ELVEHEJEM BUILDING ENVELOPE RENOVATION

0544-2214 / A-22-001 Elvehjem Building Envelope Renovation

RFI No. 15

Proposed connection installation

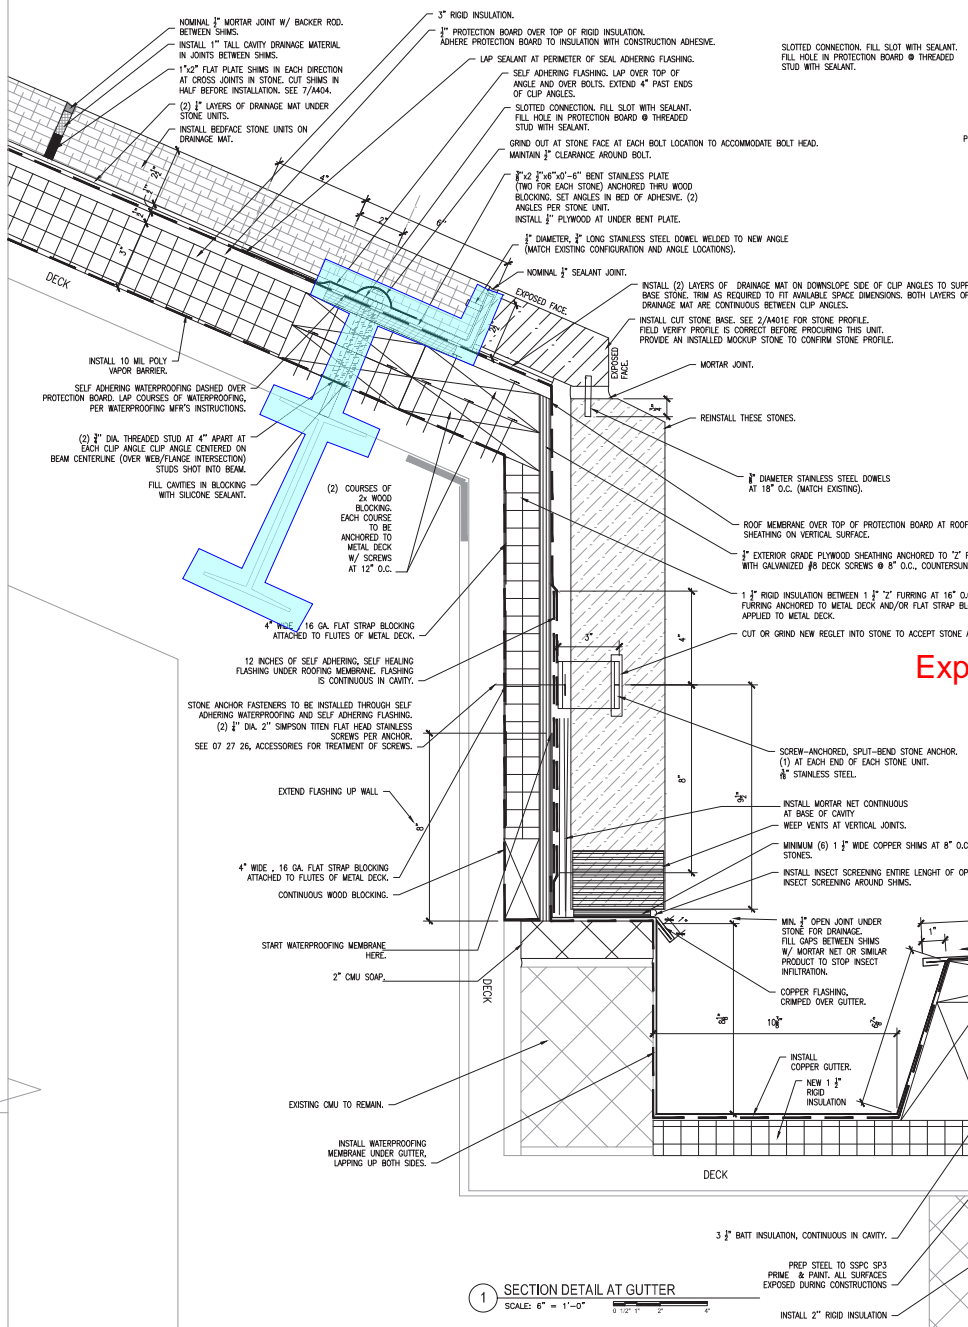
Striving to derive a countersunk bolt connection to aid roof waterproofing efforts

Drawing/Spec. Ref.: A401 - Details 1, 2

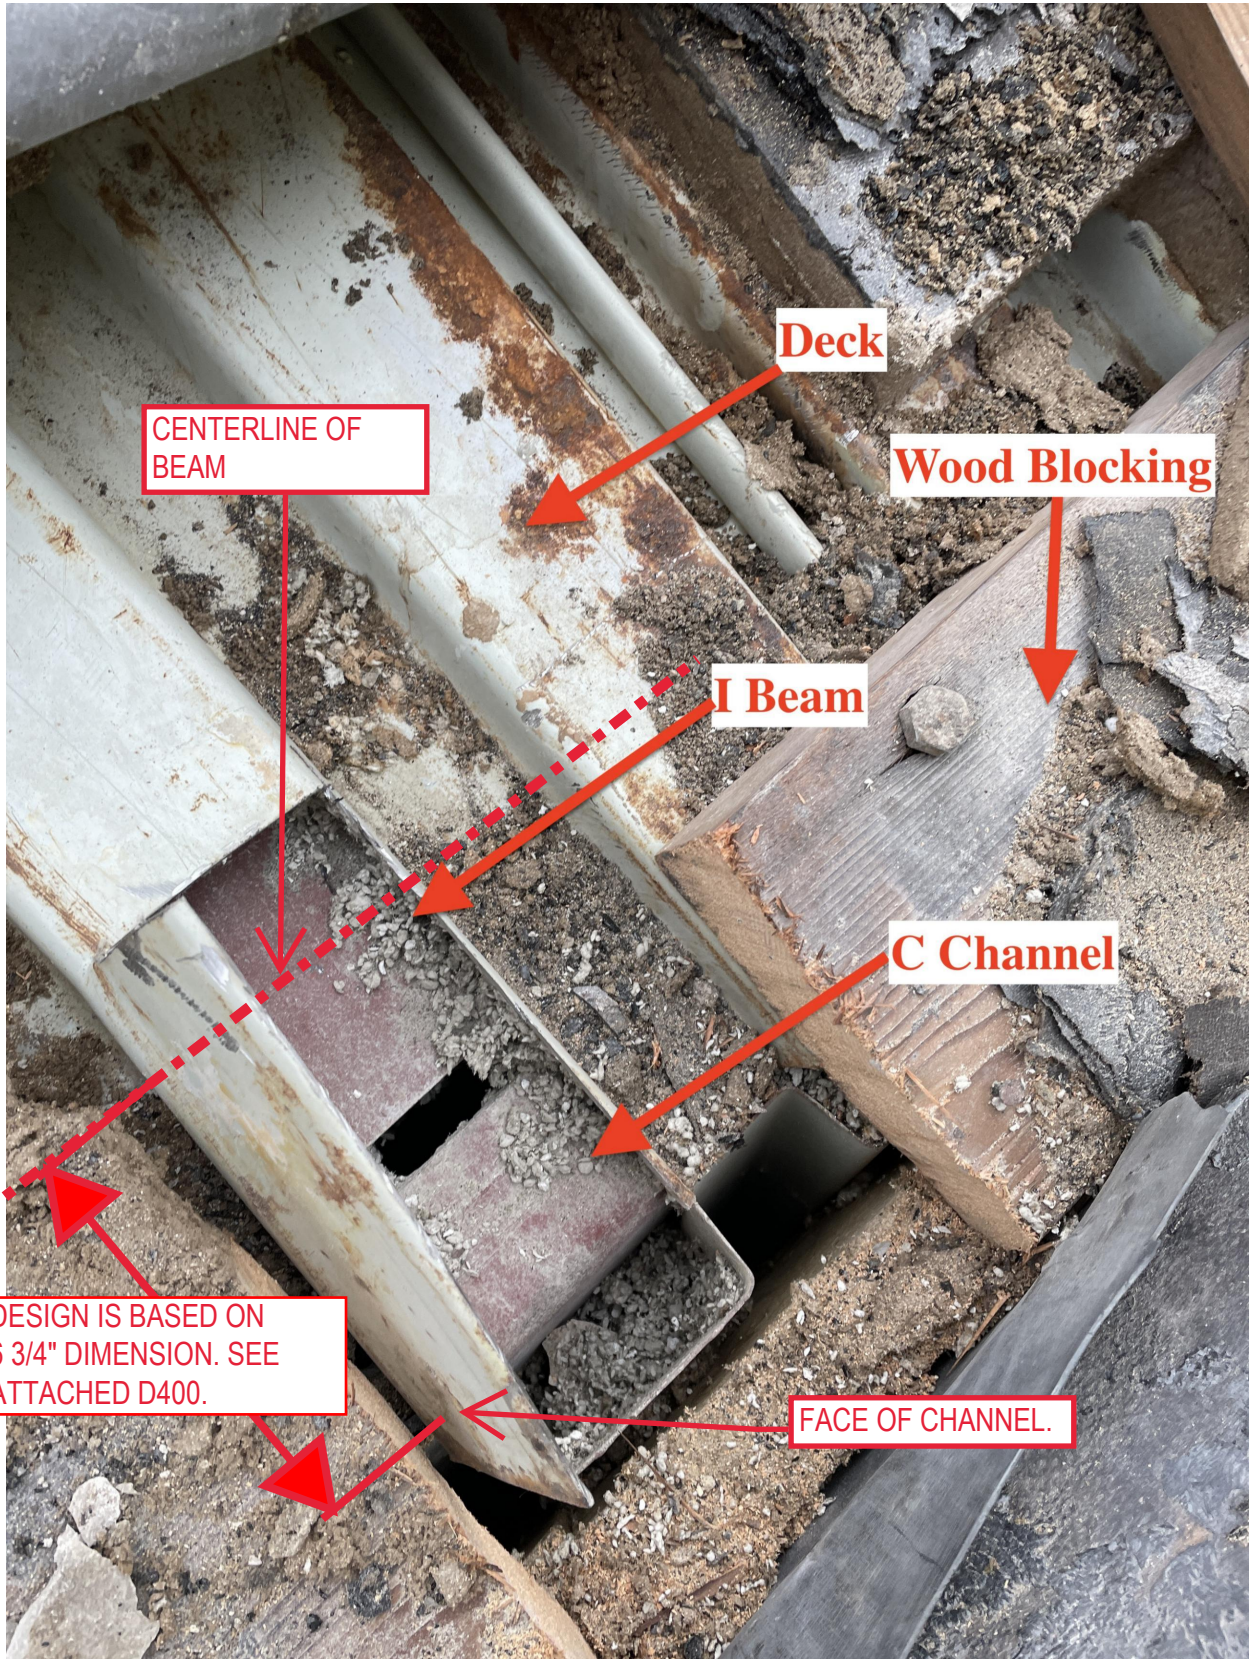
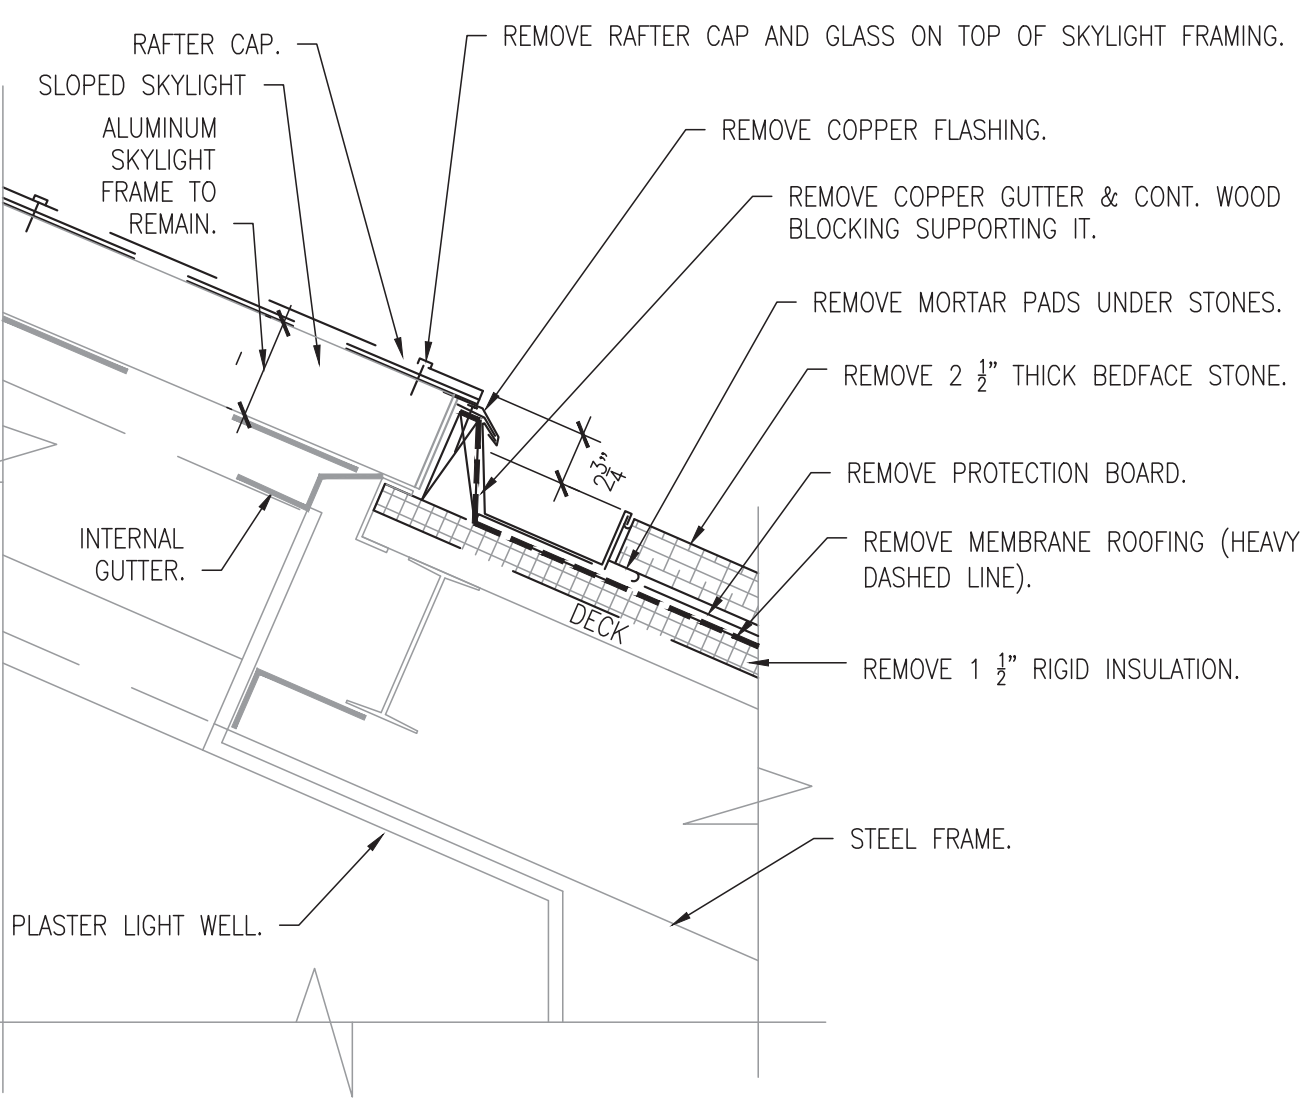
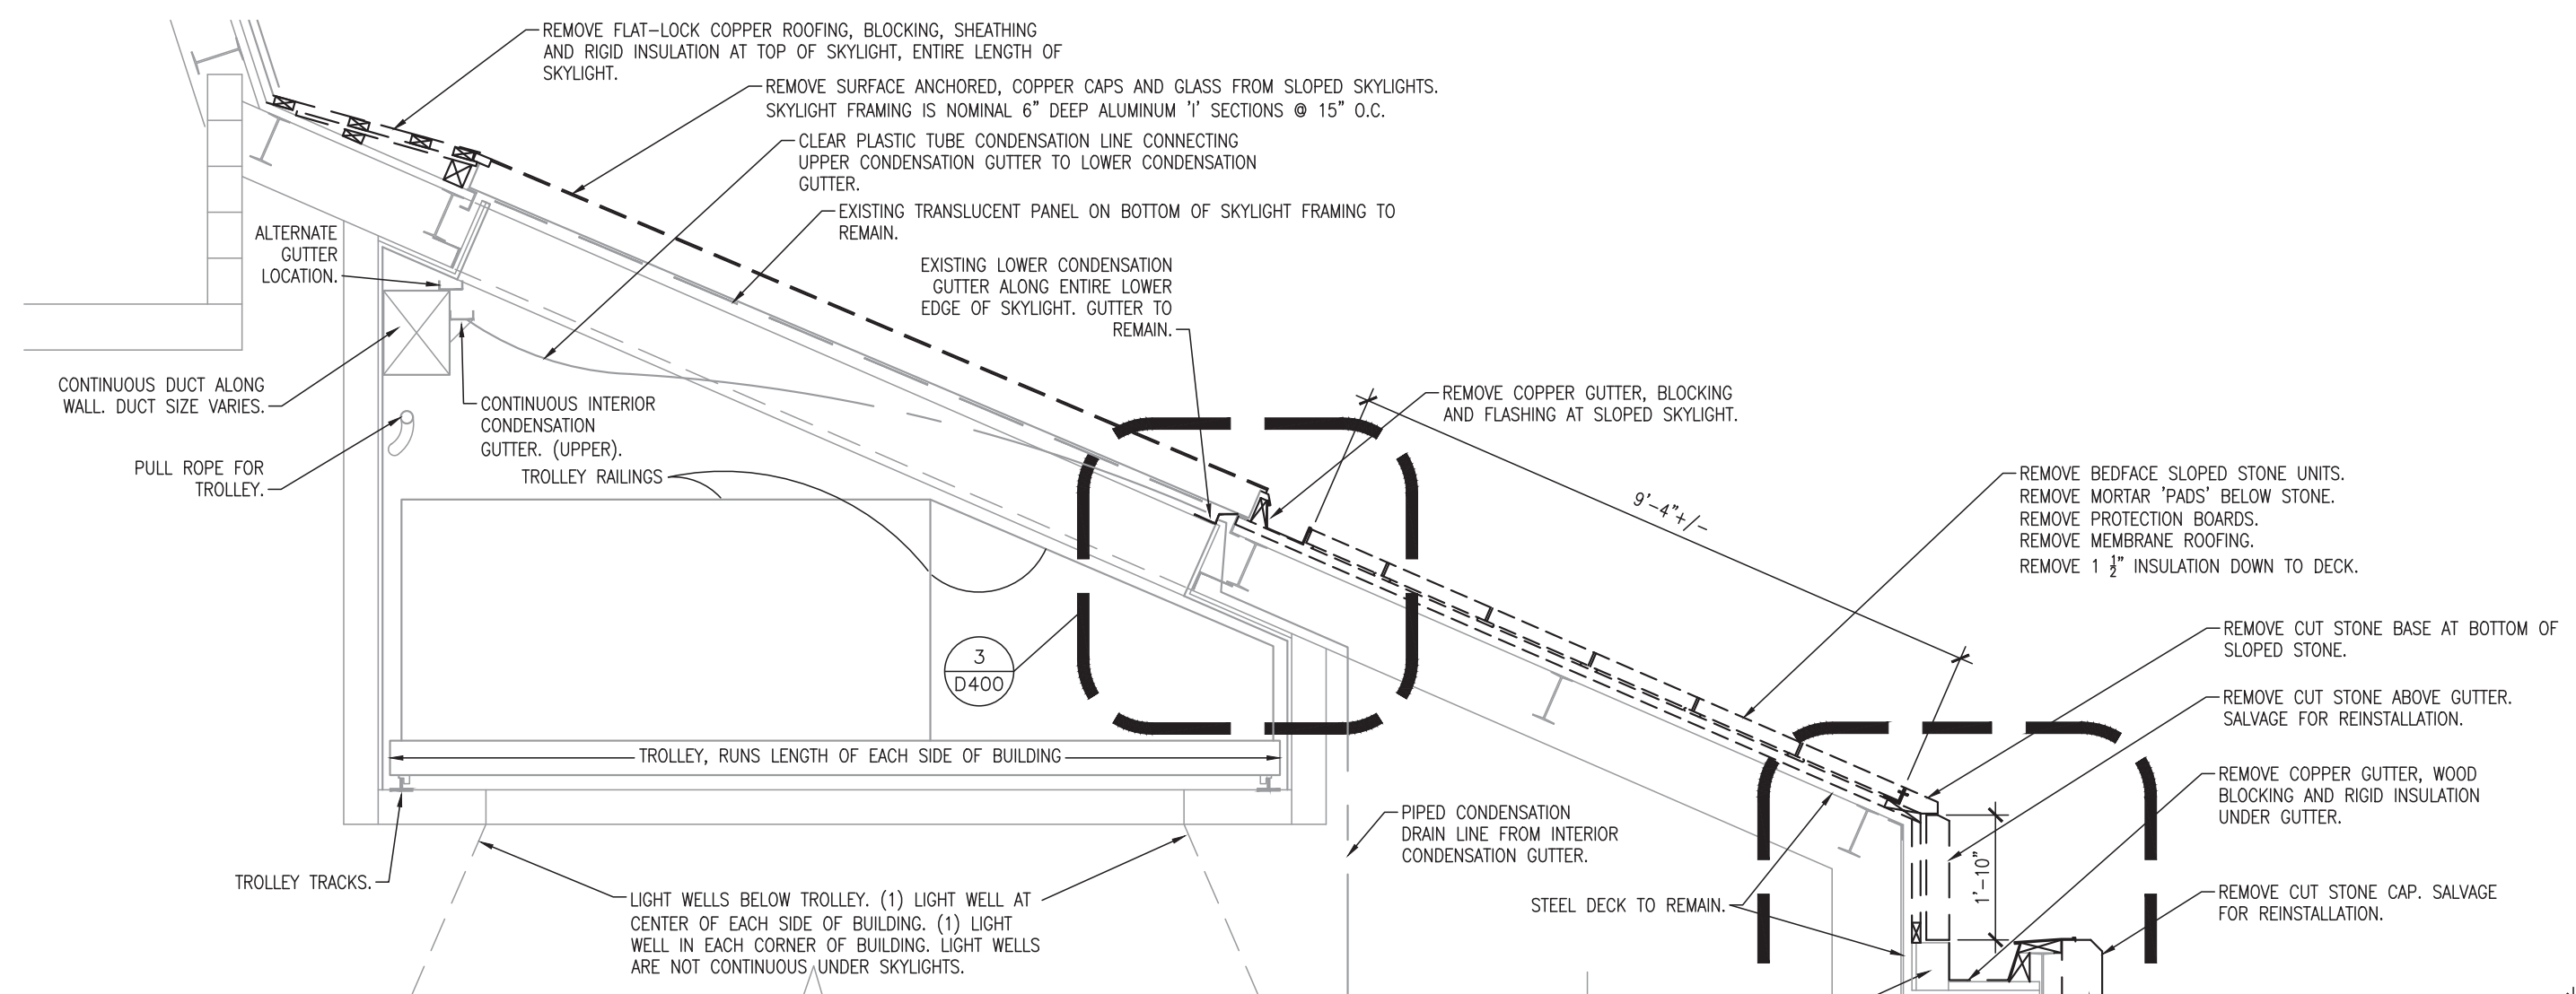
Please provide detail on anchorage, spacing, and location of the belt plate supports for the 1<sup>st</sup> and 4<sup>th</sup> courses of sloped stone. The spacing between the C-channel and the I-beam measures ~3/4". Some anchors will not line up with the flanges in the steel deck.

SEE ATTACHED SHEET A205 FOR ANGLE LOCATION AND SPACING. THE DETAIL IS STILL TO STUD WELD THE STUDS TO THE TOP FLANGE OF THE BEAMS AT THE BEAM CENTERLINE. DECK MAY NEED TO BE CUT AWAY TO ALLOW STUD WELDING TO THE BEAM BELOW IT. THE ROOF WILL NEED TO BE OPENED UP TO DETERMINE THE LOCATION OF THE UPPER BEAM. STONE MAY NEED TO BE TEMPORARILY LAID ON THE ROOF TO DETERMINE IF THERE NEEDS TO BE ANY ADJUSTMENTS TO THE BENT PLATE THAT IS ANCHORED TO THE BEAM FLANGES.
